<b>ADDENDUM NO. :</b>	<b>Four (4)</b>
<b>BID DUE TIME AND DATE:</b>	2:00 p.m., April 30, 2019 <b>(No Change)</b>
<b>BIDDER QUESTIONS BY:</b>	11:59 a.m., April 23, 2019
<b>LAST ADDENDUM ISSUED:</b>	11:59 p.m., April 25, 2019

**THE PURPOSE FOR THIS ADDENDUM IS:**

- **To provide a response to questions raised by Plan Holders;**
- **To modify/clarify specifications and drawings.**

**A302**

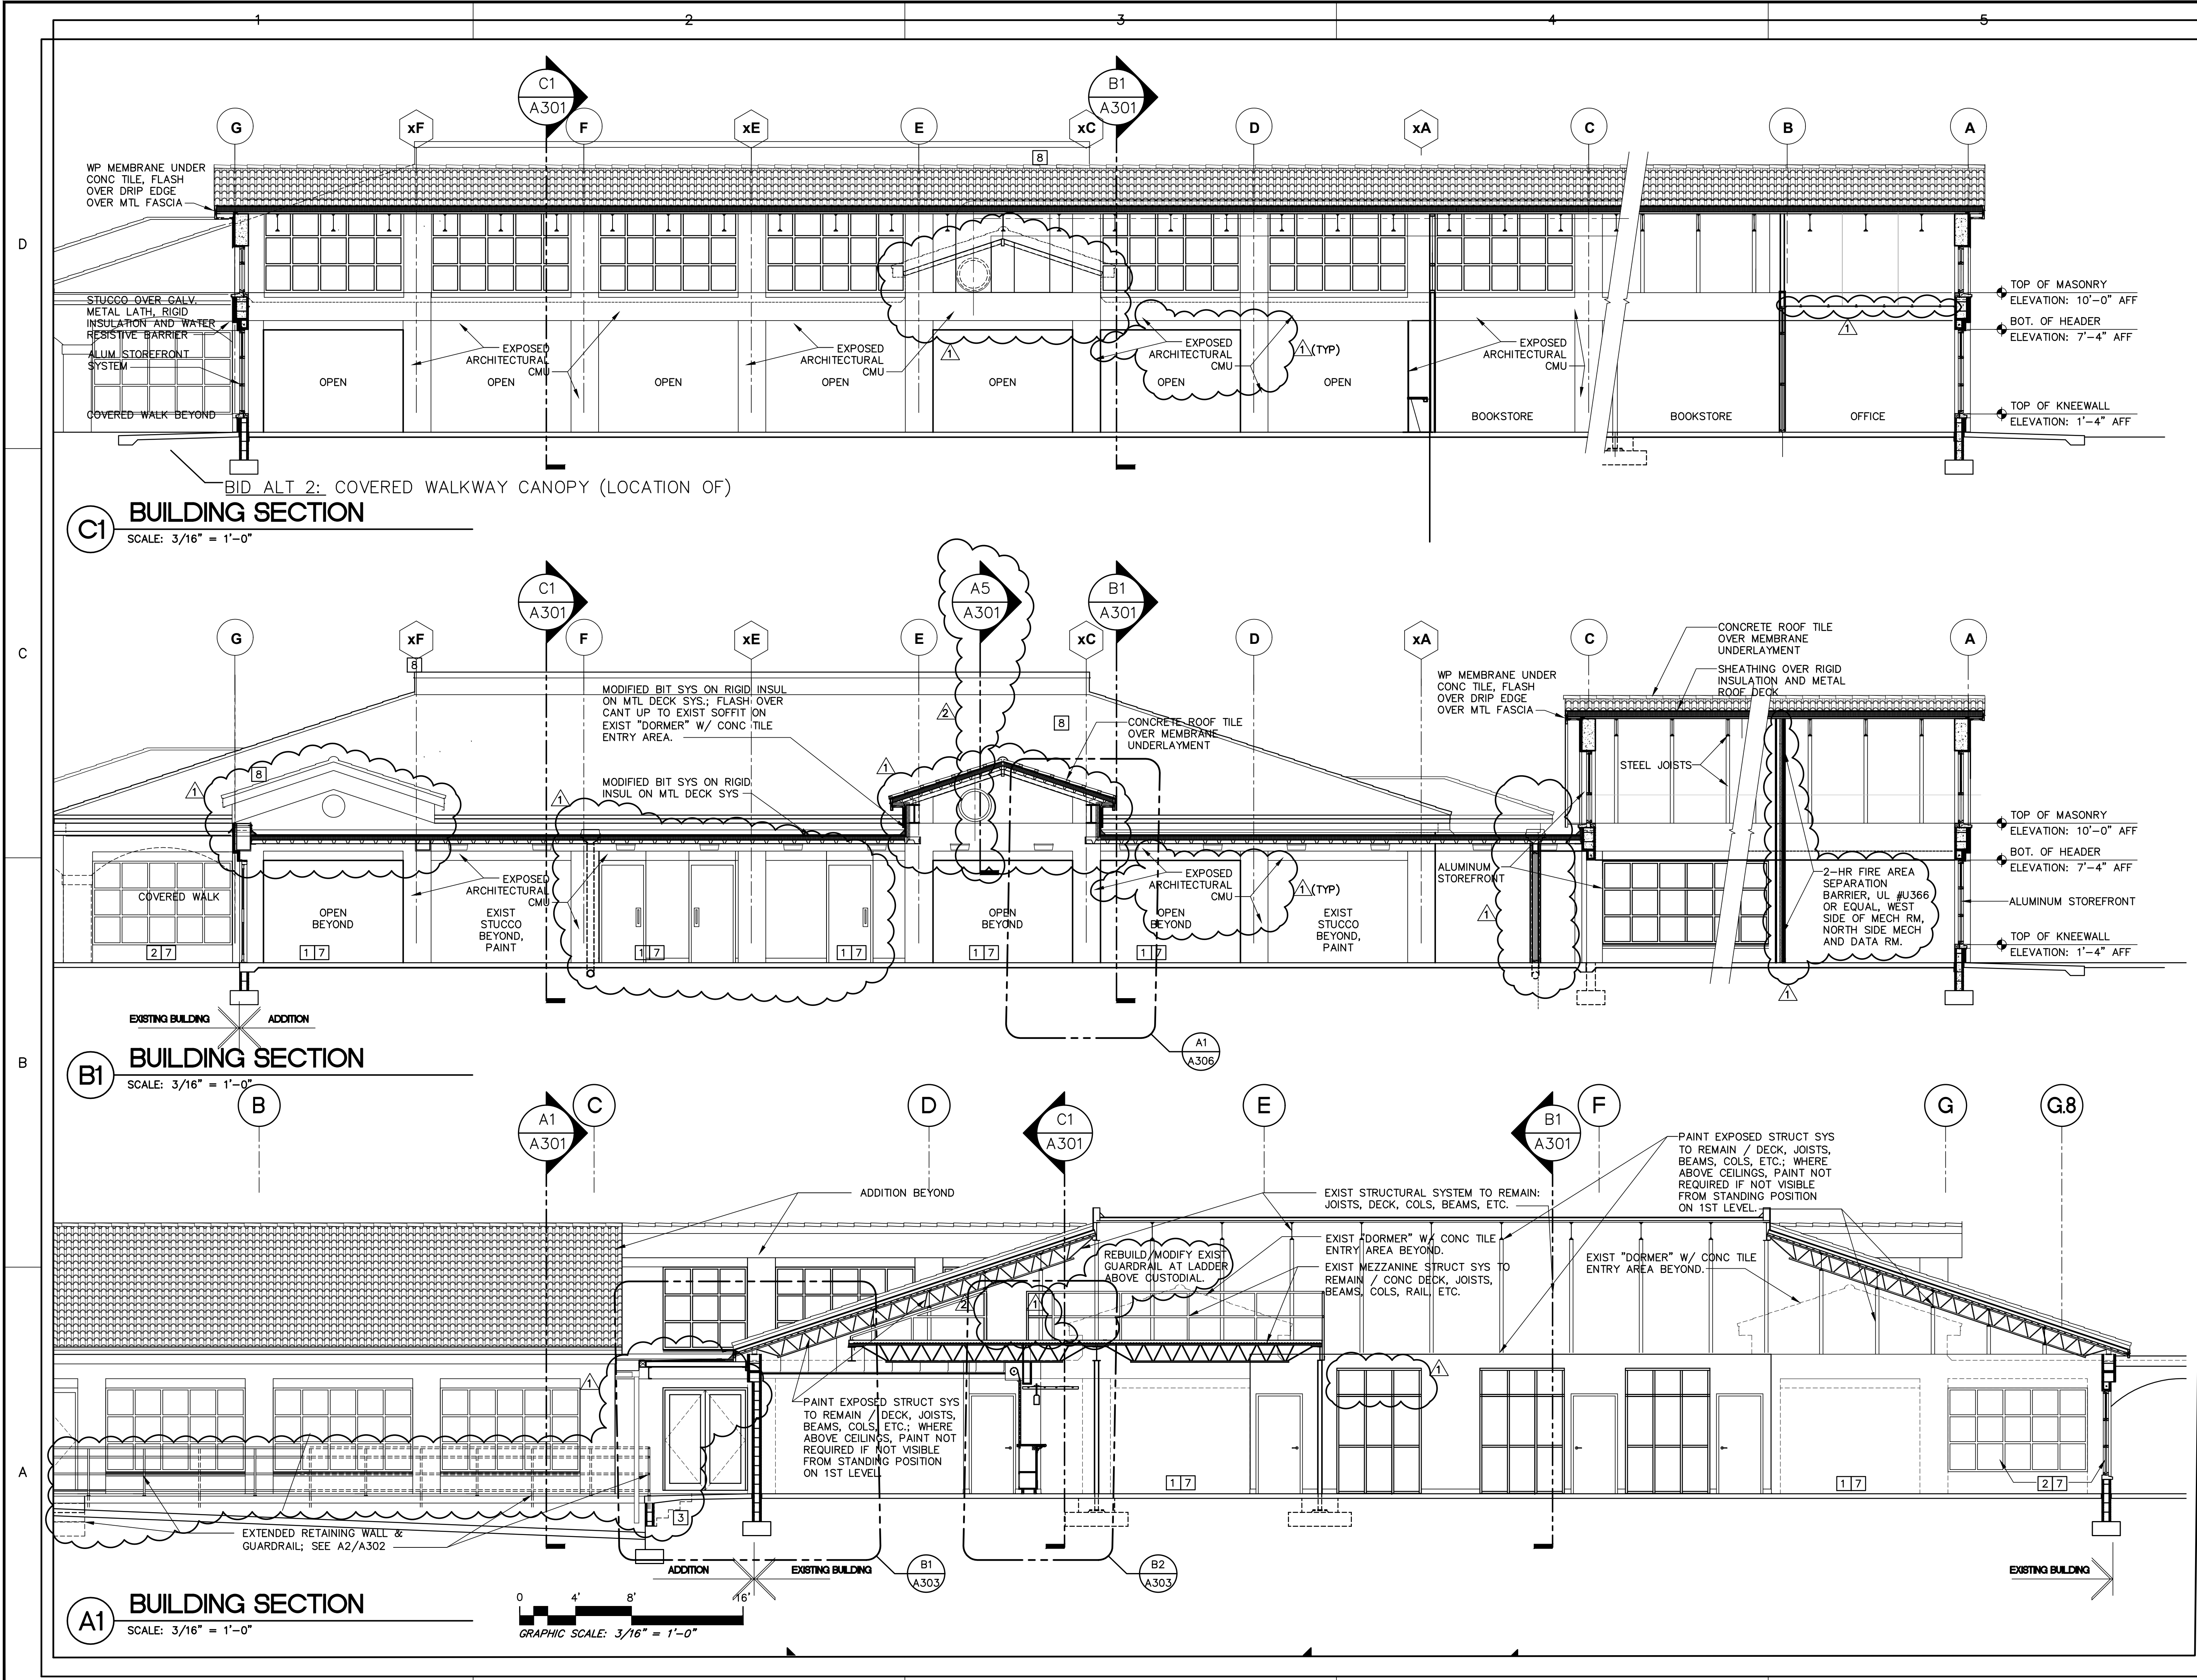
- A301 Building Sections
- A302 Building Sections
- A303 Ext Wall Sections & Details
- A304 Ext Wall Sections & Details
- A306 Ext Wall Sections & Details
- A502 Ceiling Details
- A601 Finish Schedule w/ Details
- P101, Updated plan to show missing fixtures and missing sanitary and vent piping
- P102, Updated plan to show missing fixtures, missing domestic water piping and missing gas piping
- P101, Updated plan to show missing fixtures and missing sanitary and vent piping
- P201, Updated plan to show missing fixtures and missing sanitary and vent piping
- P202, Updated plan to show missing fixtures, domestic water piping and missing gas piping
- M401, Added detail for chilled water connections to AHU
